Corrigendum - 5 dated 16/10/2025 to CPC Tender No. BHEL/CPC/YNR/EPC-AHP/26/041

“EPC package for Ash Handling Plant at Yamunanagar Super Thermal Power Project (1x800 MW)”

A) Replies to Bidder’s queries as mentioned below:

DRAWING NO. PE-DG-510-100-M001

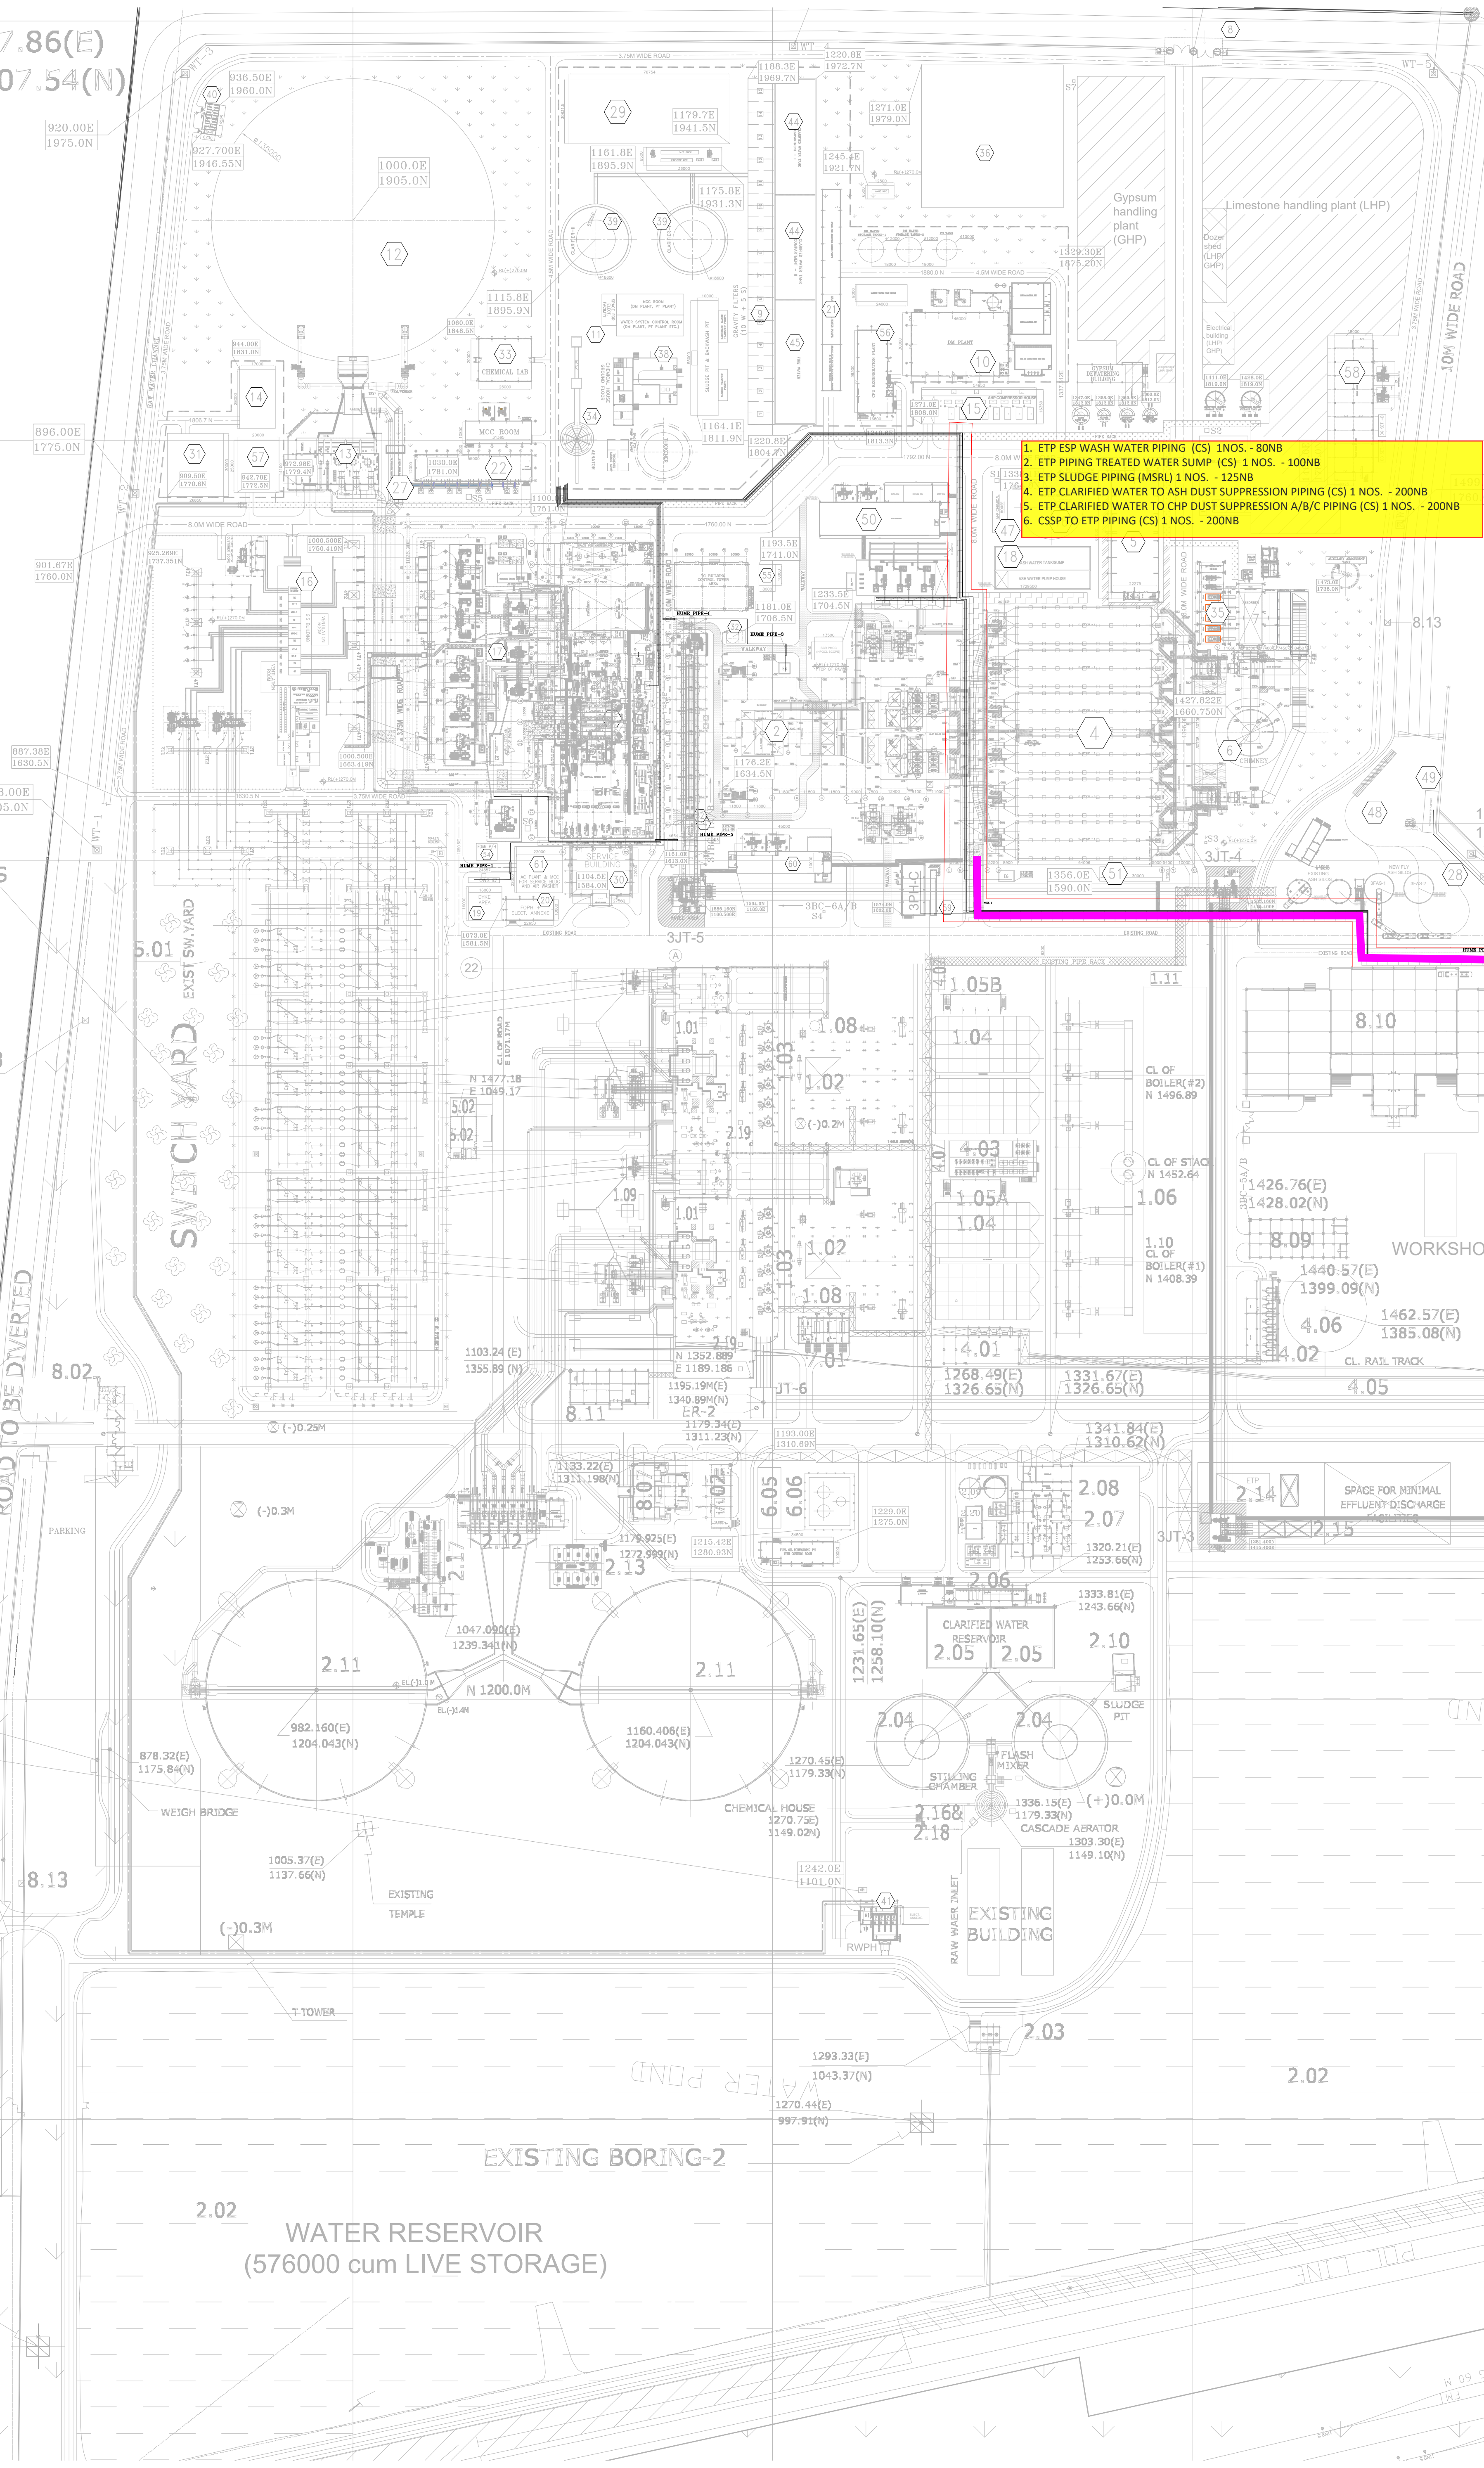
AHP bidder to consider 4 nos 600W cable trays for BHEL other package in the AHP pipe rack. (supply of Tray is not in bidders scope)
